March 22, 2024

RE: Request of Grissim Metz Andriese Associates on behalf of UAW-Ford for PC (Public Center) Special District Review of proposed changes including new landscaping and signage at 151 West Jefferson Avenue. **(RECOMMEND APPROVAL WITH CONDITIONS)**

UAW-FORD JOINT TRUSTS CENTER - W. JEFFERSON AVE. ENTRANCE

ONE (1) INTERNALLY ILLUMINATED MONUMENT SIGN WITH EMC, DOUBLE-SIDED MOUNTED ON AN EXISTING MARBLE BASE
Scale: 3/8" = 1'-0"

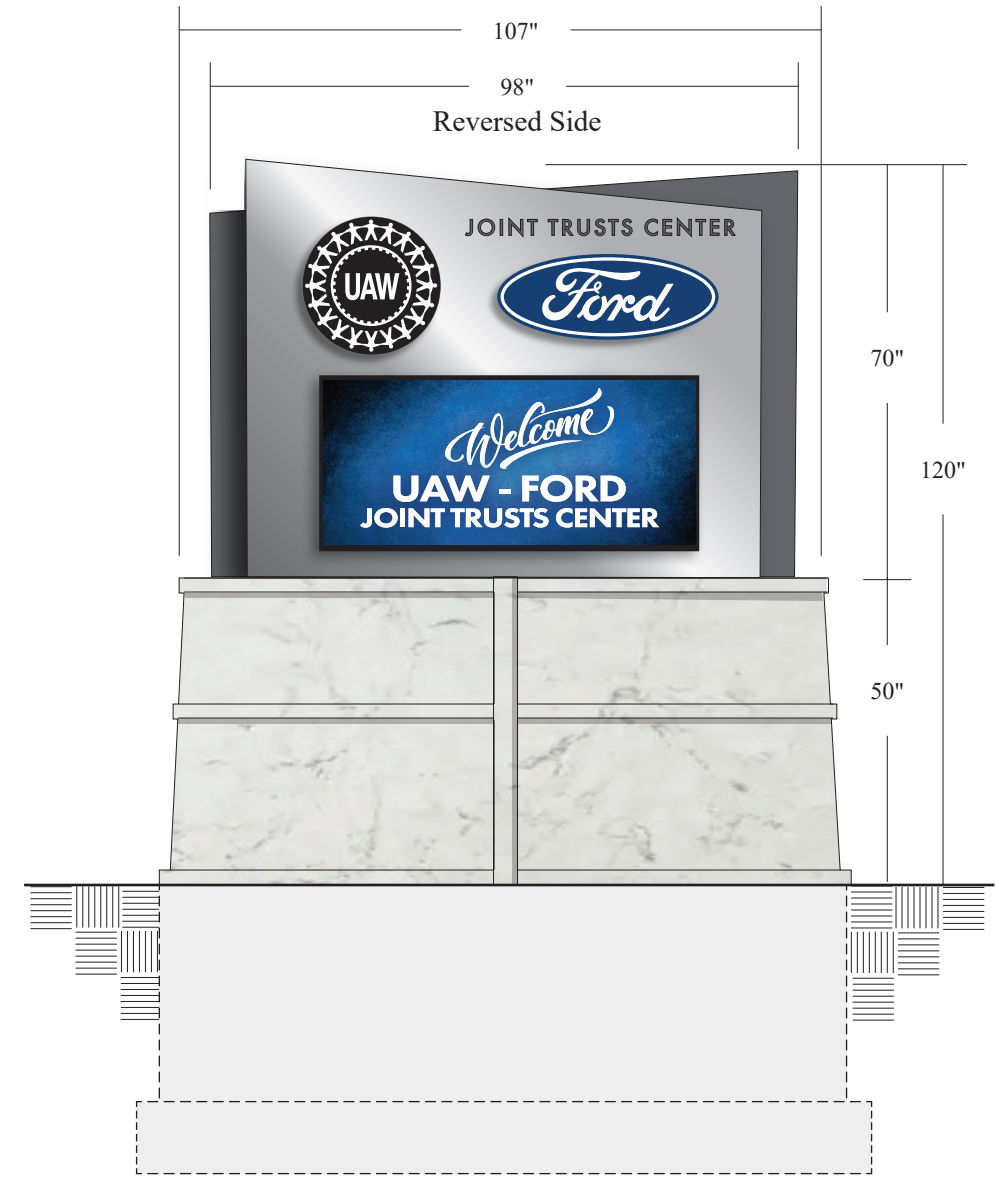
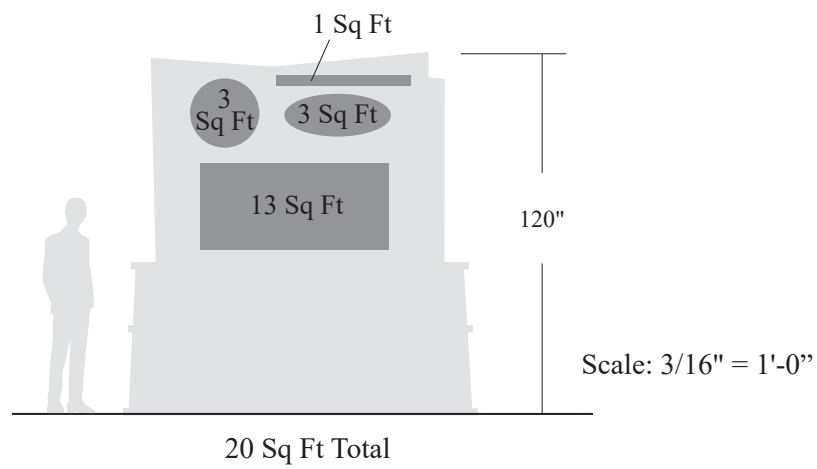
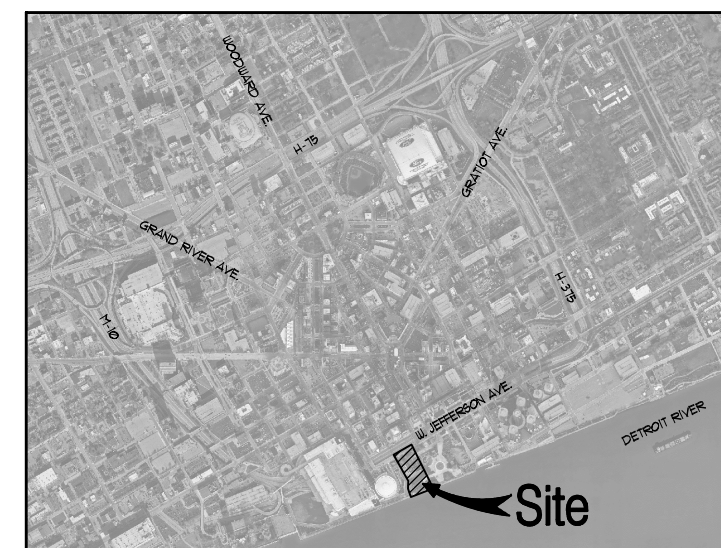
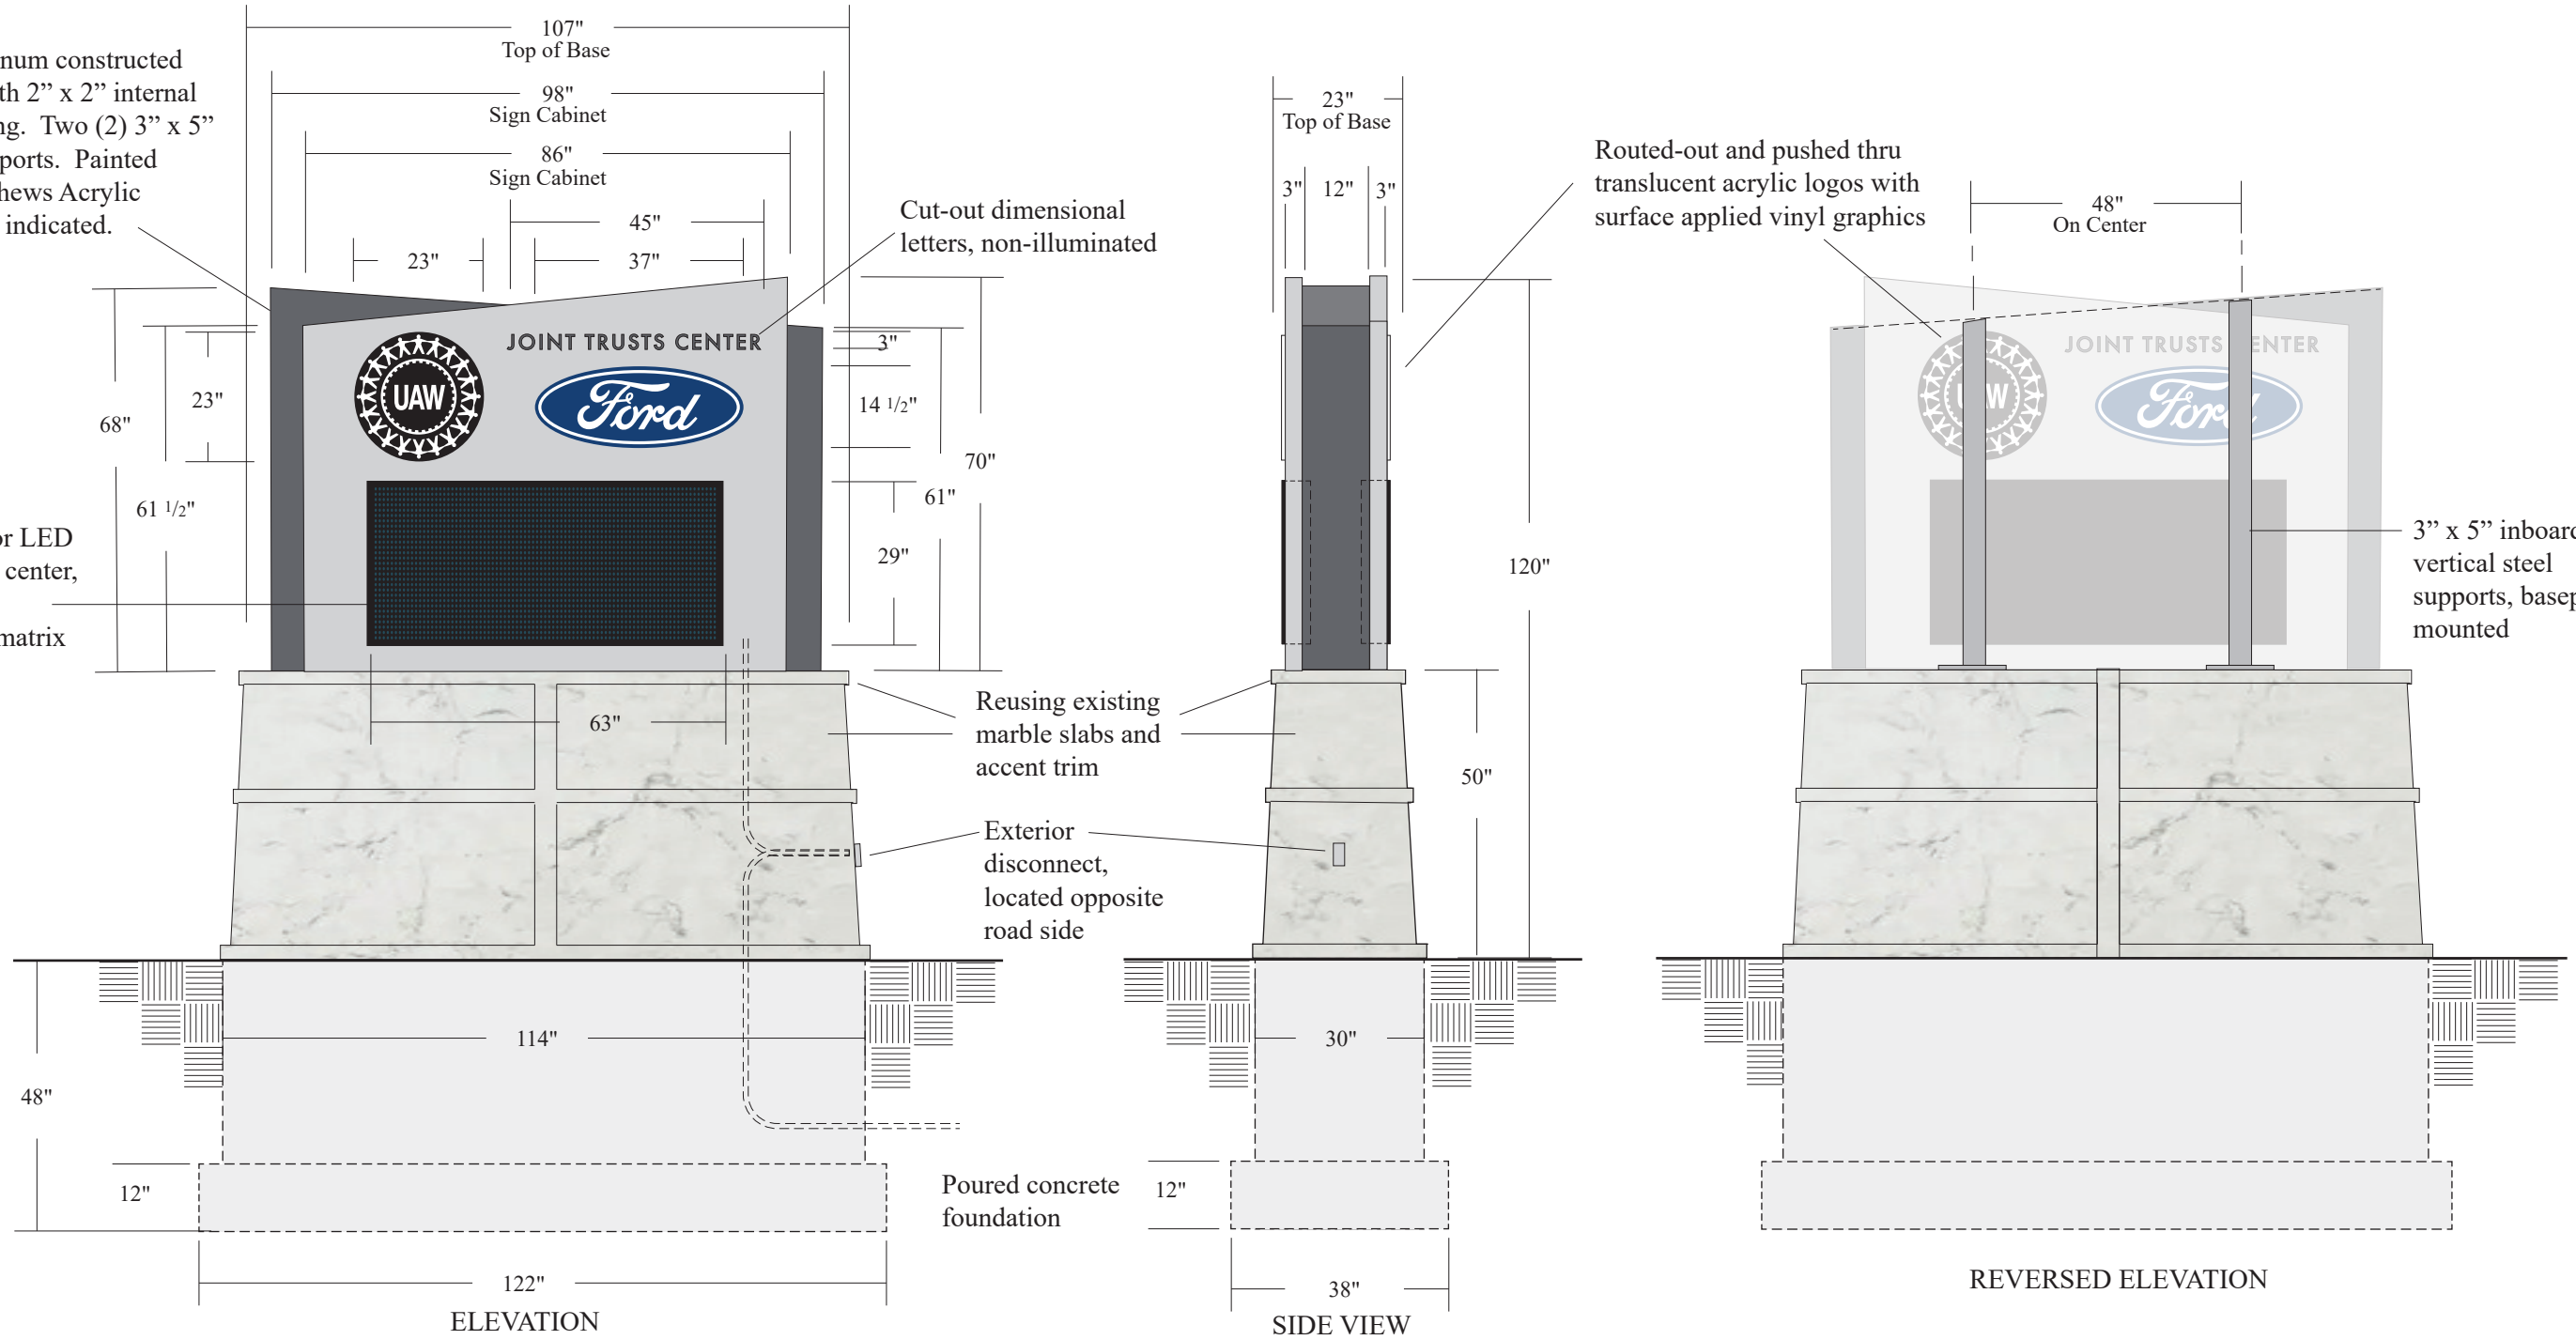
The materials of the proposed sign coordinate well with the building. Decreasing the height of the sign and illuminating the logos will make it more readable to passing traffic.

Criterion 2: Scale, form, massing and density should be appropriate to the nature of the project and relate well to surrounding development; The sign is somewhat smaller than the current sign and is appropriate for the site.

Criterion 11: Signage and graphics should be tastefully designed to be visually appealing and in character with surrounding development; they should provide needed information, direction and orientation in a clear and concise manner; The continued use of the marble with stainless steel continues the modern aesthetic of the building.

1. The electronic message board shall be operated solely as an on-premises sign and display messages or images related to onsite activities and events only.
2. The electronic message board shall only display static images and not flashing, moving or animated images.
3. Each image or message shall be displayed for a minimum of eight (8) seconds.
4. That final plans be reviewed by CPC staff for consistency with approval prior to application being made for applicable permits.

The Planning and Development Department **supports** the proposed sign change.

Sheet:
Paving & Layout Plan

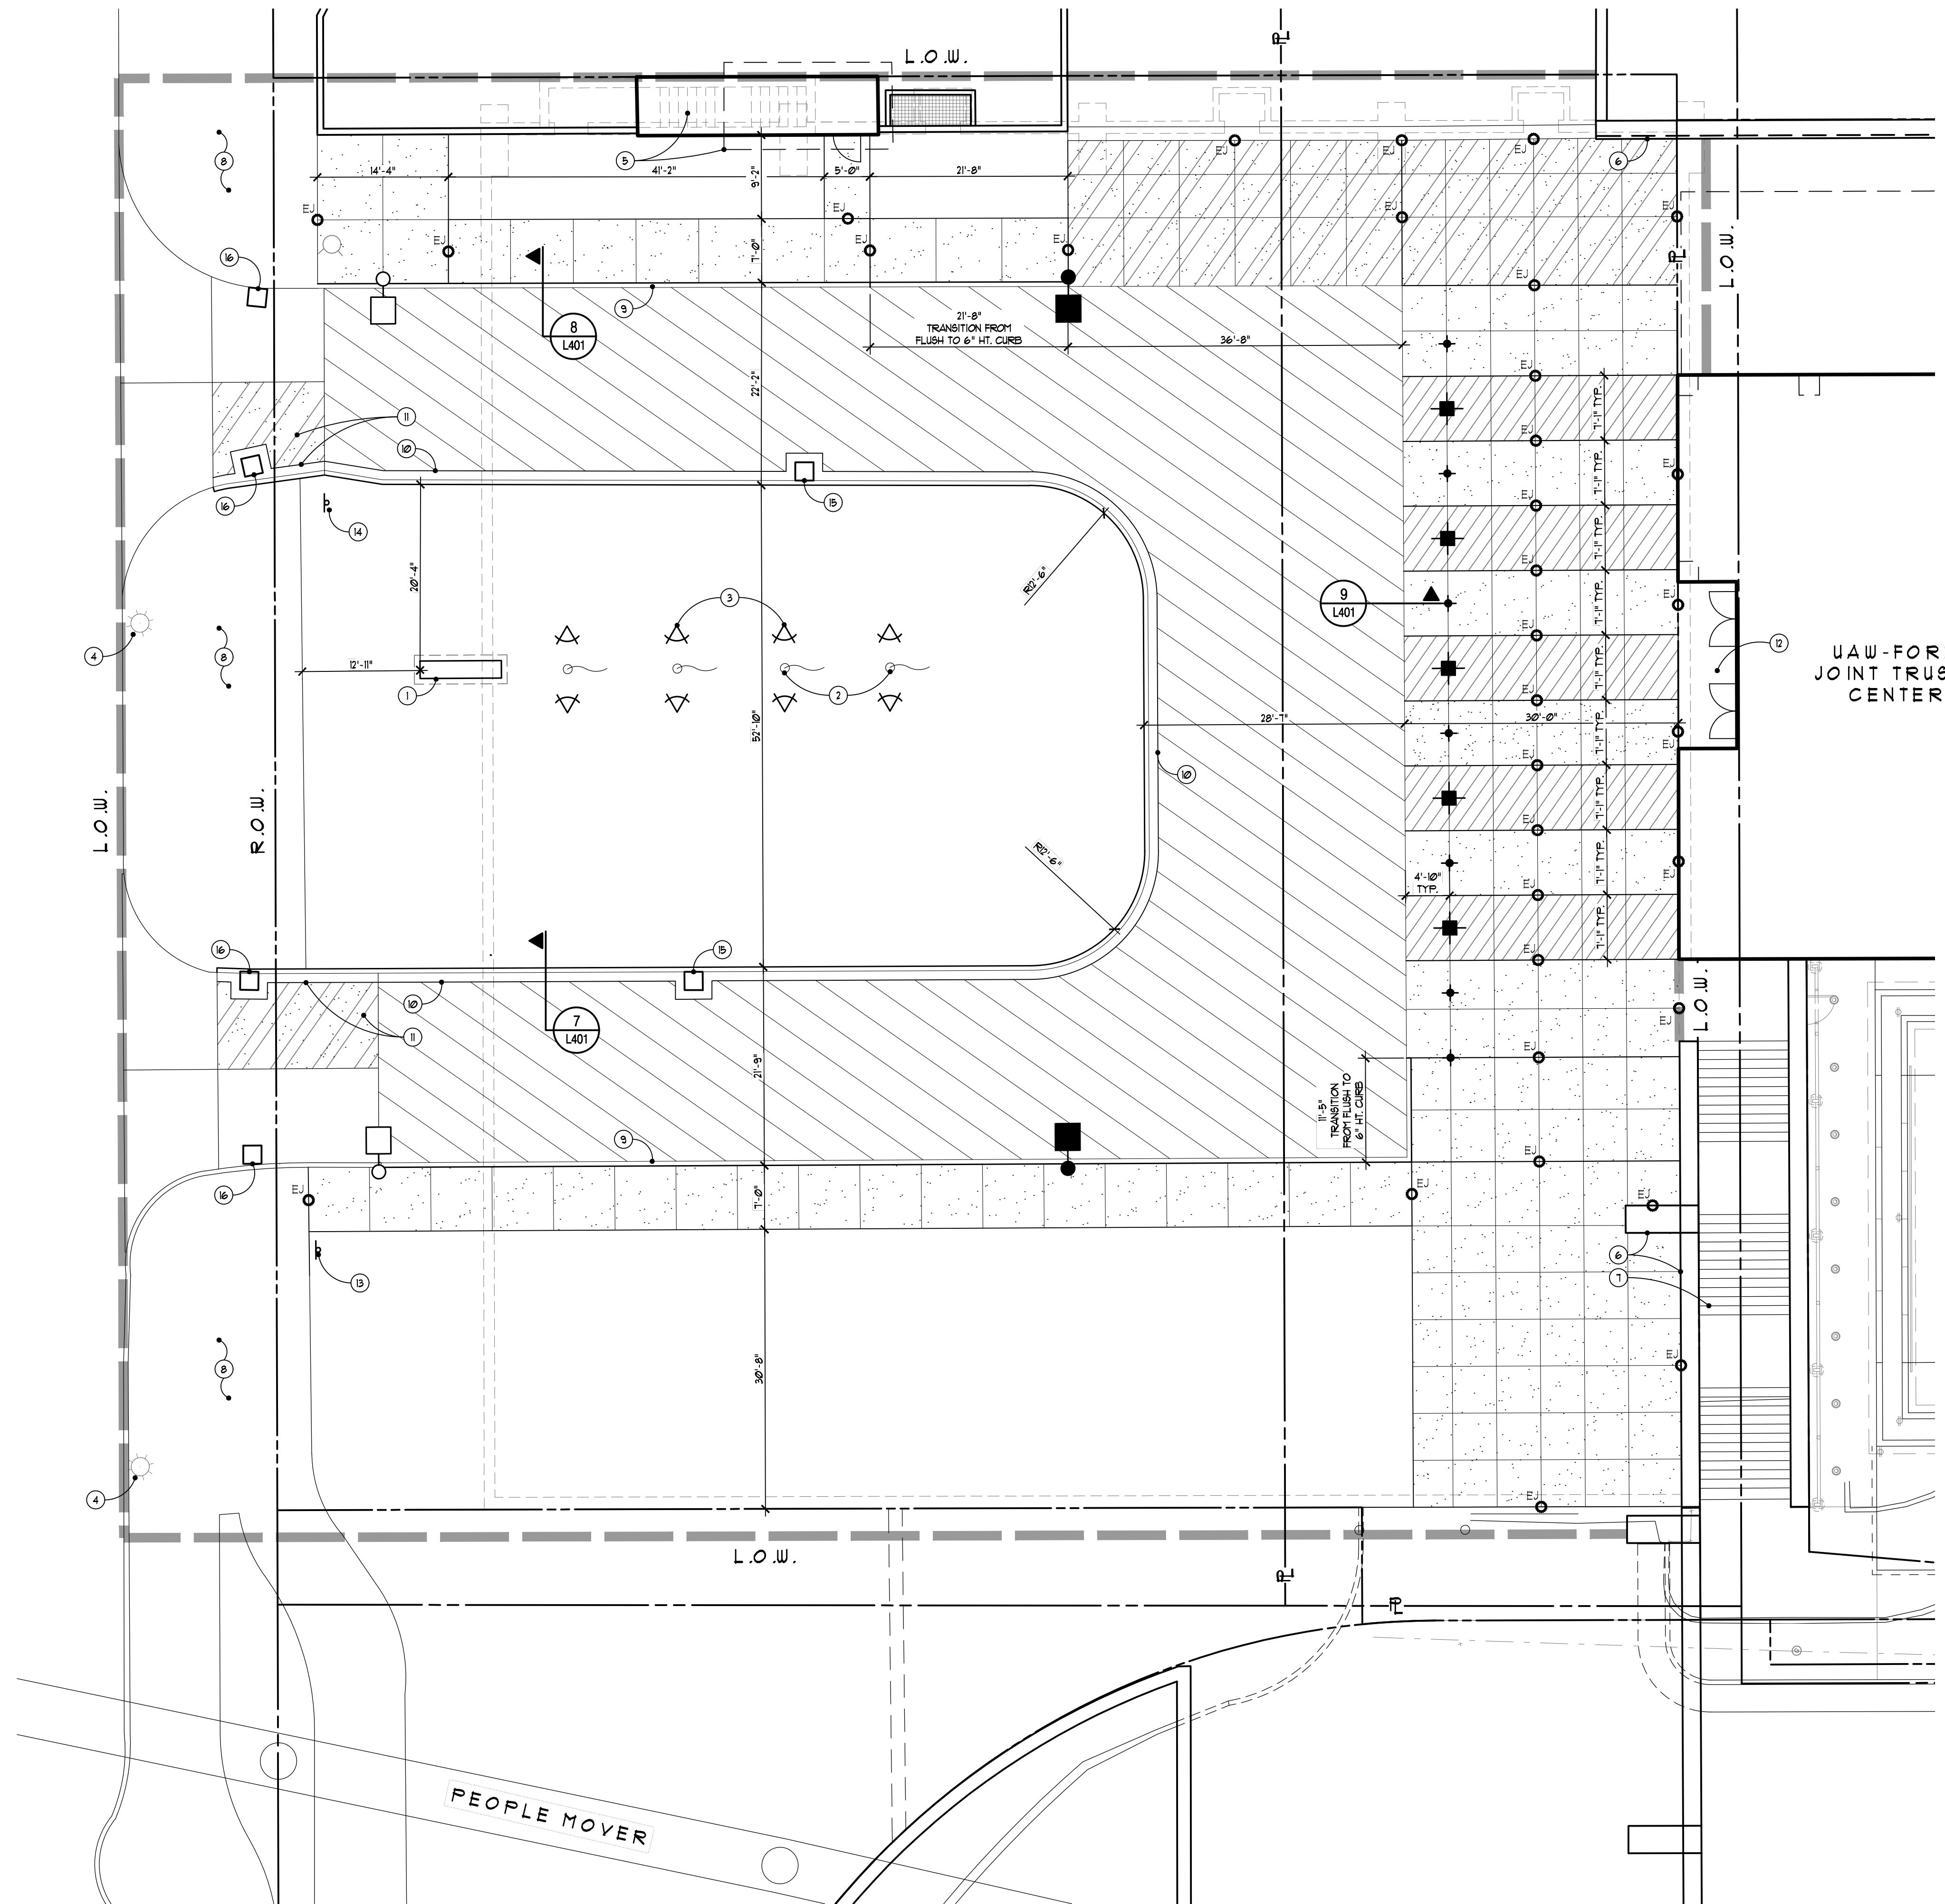
Criterion 1: The proposed development should reflect applicable policies stated in the Master Plan; The site's Future General Land Use designation is "Special Commercial", and the description of that classification states that "... automobile parking located on the street or in structures. Ground level activity should be pedestrian-oriented.". Additionally, Policy 9.2 is "Promote parking in structures with ground level commercial activity." The removal of the surface parking lot meets this. We recommend that signs state there be "no parking" in the drop-off loop to ensure that the drive is only used for drop-offs and that there be additional pylons to the east of those proposed to ensure that vehicles don't park on the sidewalk..

The Planning and Development Department **supports** the proposed site changes, with the requirement that there be signs stating there be "no parking" in the drop-off loop and additional pylons.
